# BendPak Technical Service Bulletin

## GP-9 and D4-9 Series – Small Spacer Orientation

### BendPak TSB 81 – 082021

The following drawing shows the **old** and **new** orientation for the Small Spacer in the Crosstube Sleeve.

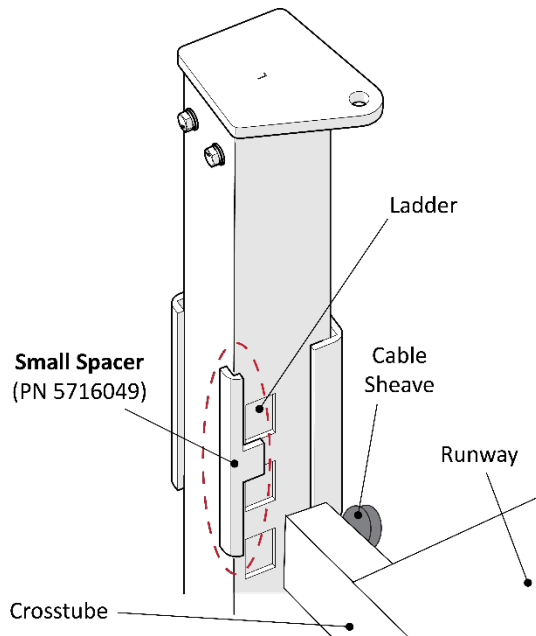
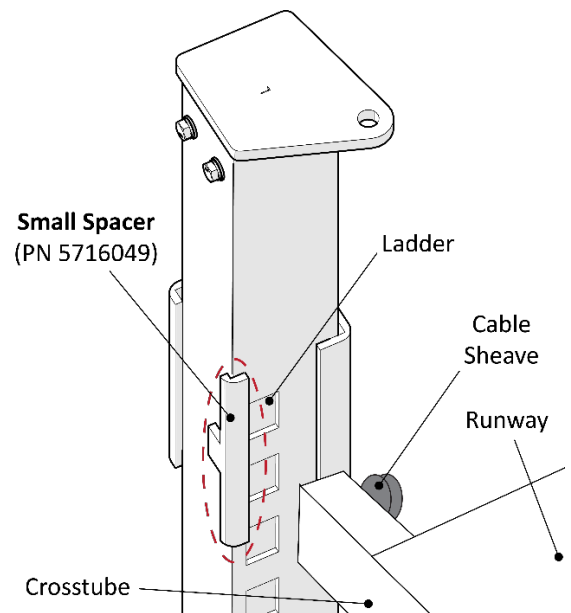
The purpose of this Technical Service Bulletin is to describe the new orientation for the Small Spacer (P/N 5716049) currently not shown in the Installation Manual.

**What you need to do:** Rotate the Small Spacers so that the middle tabs are facing **away** from the Ladders on the Lift Post; one Small Spacer per each Lift Post.
